ADDENDUM NO. 1

April 23, 2024

Whiteland Community High School Phase 2A
300 E. Main Street
Whiteland, IN 46184

This Addendum consists of Pages ADD 1-1 through ADD 1-2 and attached Specification Sections 01 21 00 – Revised Contract Allowances, Logistics Plan, Guideline Schedule, and Lancer Associates Architecture Addendum No. 1, dated April 23, 2024, consisting of 63 Pages, Specification Sections 11 68 33 – Field Events & Athletic Equipment, 32 18 23 – Track Surfacing Latex System, 32 31 13 – Chain Link Fencing and Gates, 33 14 17 – Site Water Utility Service Laterals, 33 42 00 – Stormwater Conveyance, and Drawings 100, 210, 302, 303, 400, 401, 402, 403, 500, 501, 600, 601, 700, 900, 901, 902, 903, 904, 1004, L101, L102, L201, L202, L402, ES102, ES103, and ES301.

ELECTRICAL DEMOLITION SITE PLAN
SCALE: 1" = 50'-0"

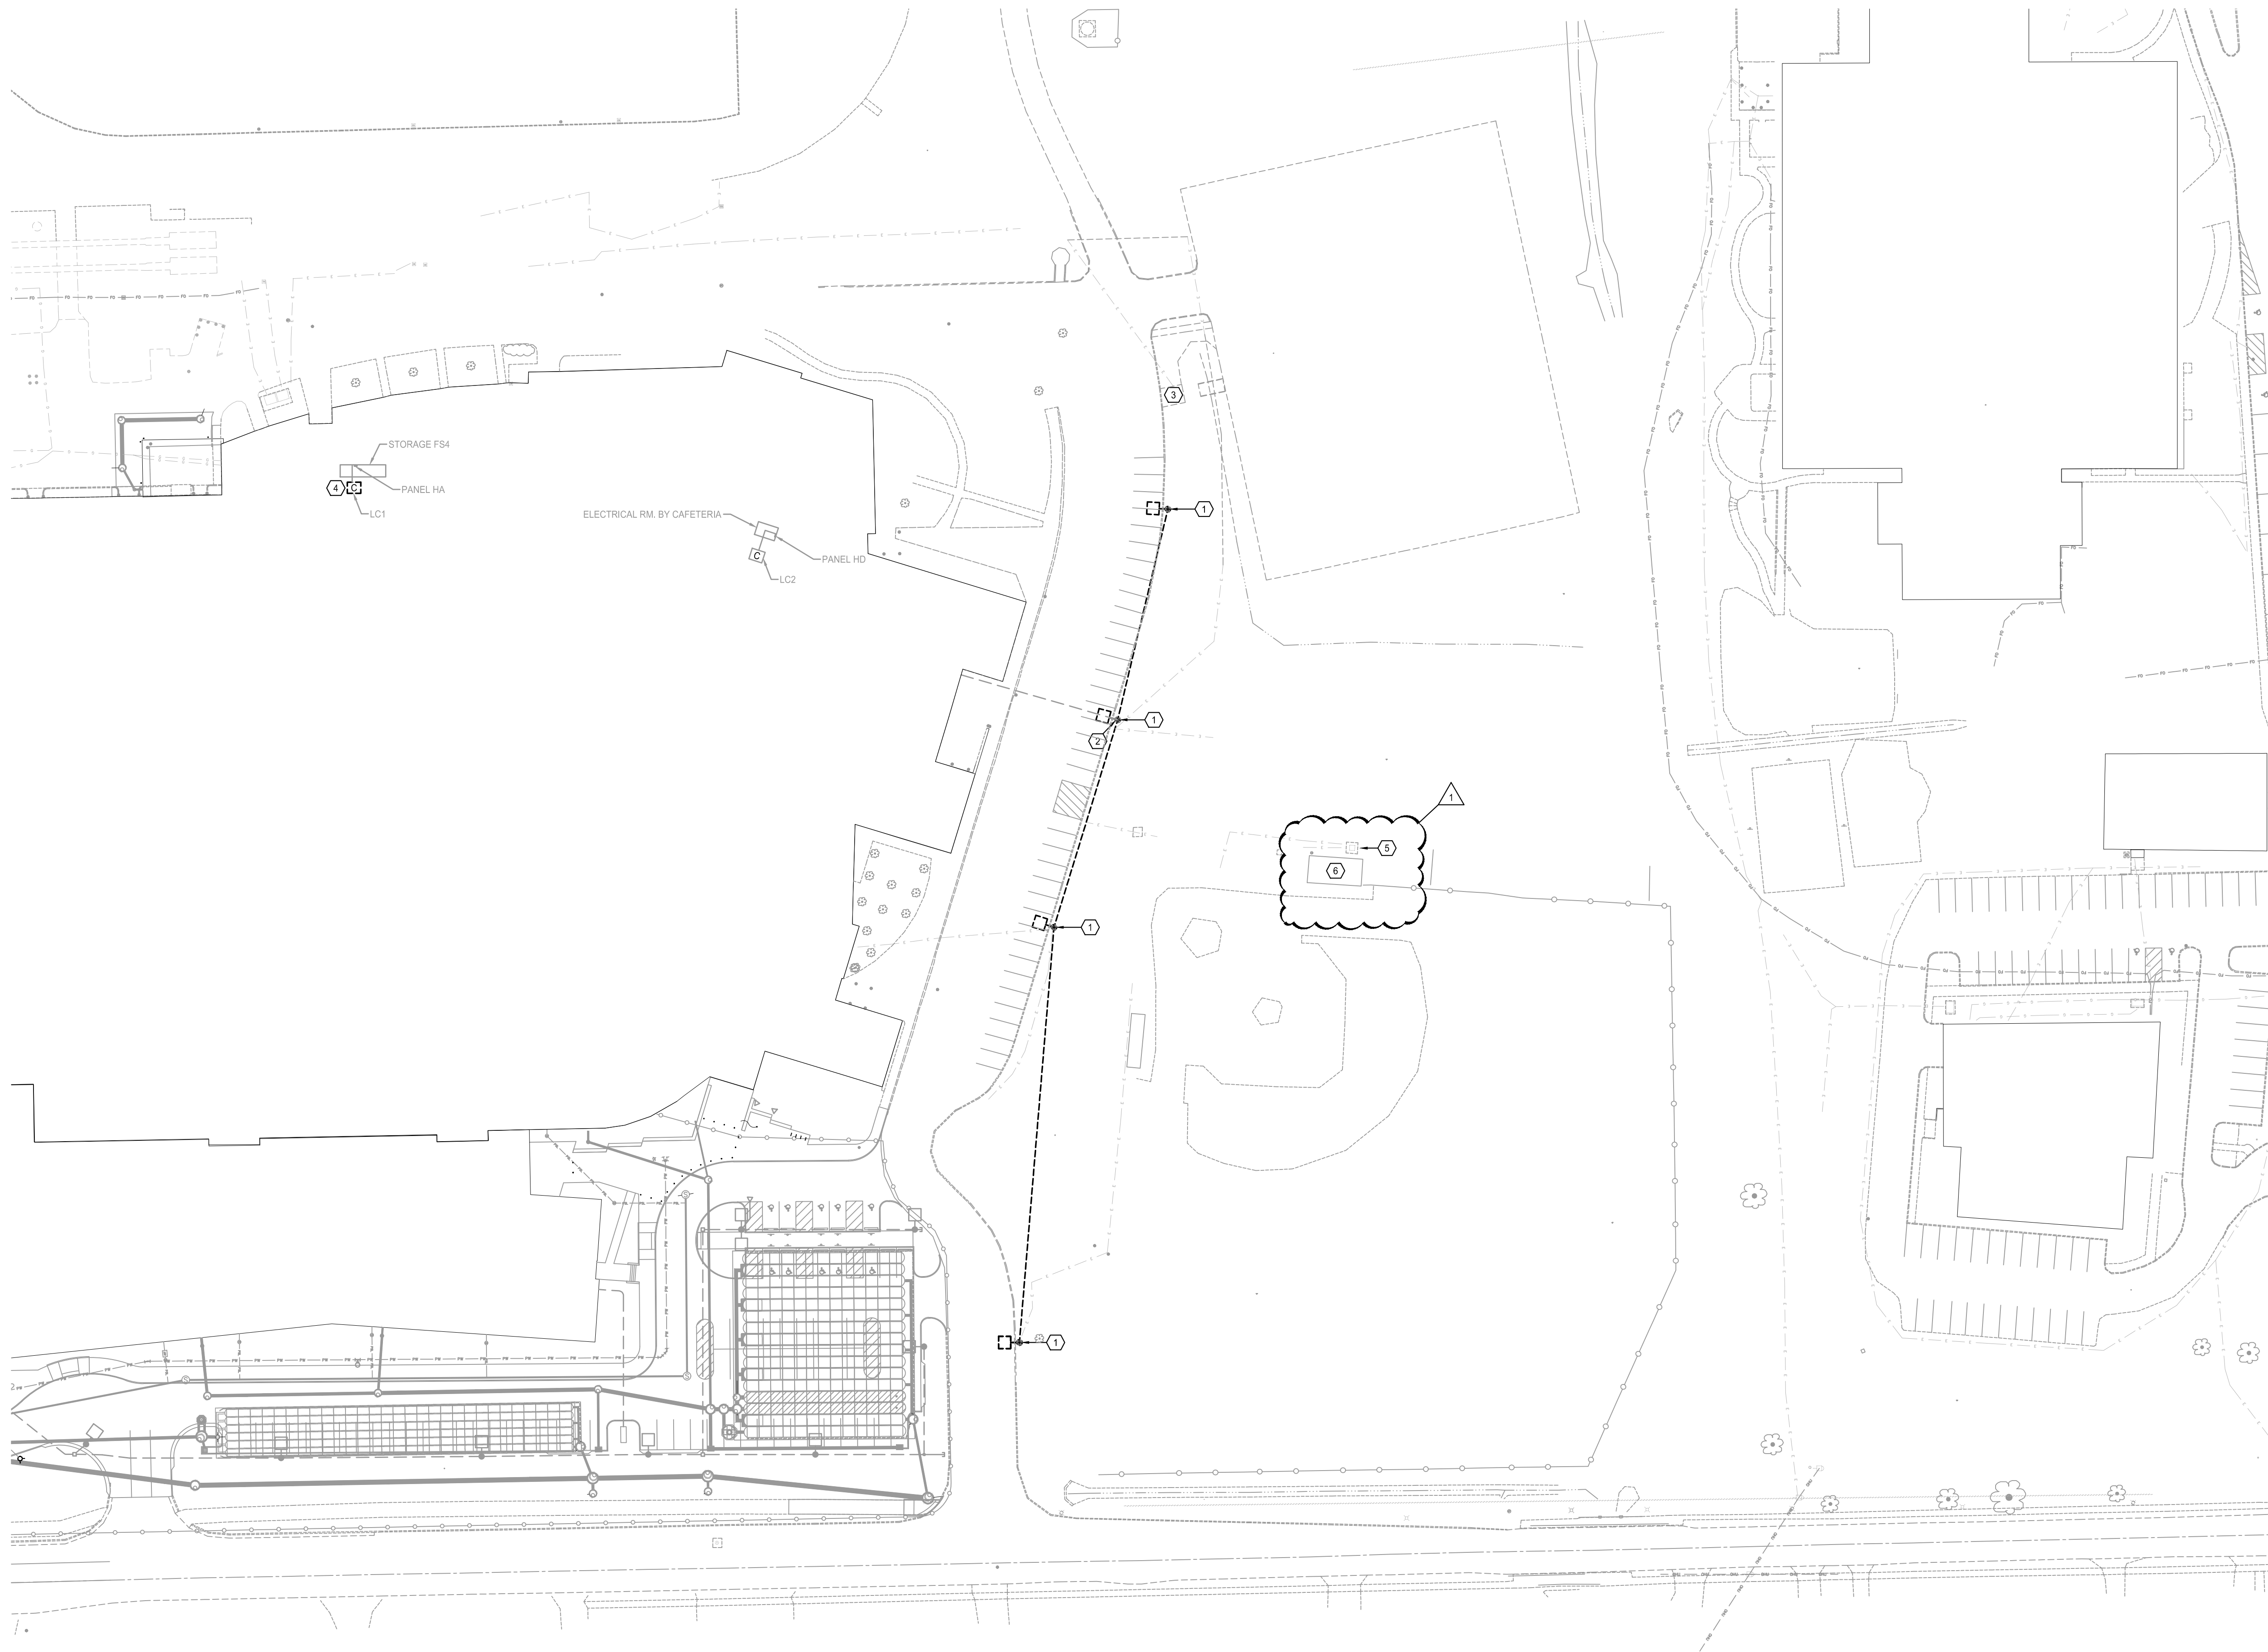
- a) Drawing #1: Added plan note #5 and #6.
- b) Plan notes: Revised Plan notes.
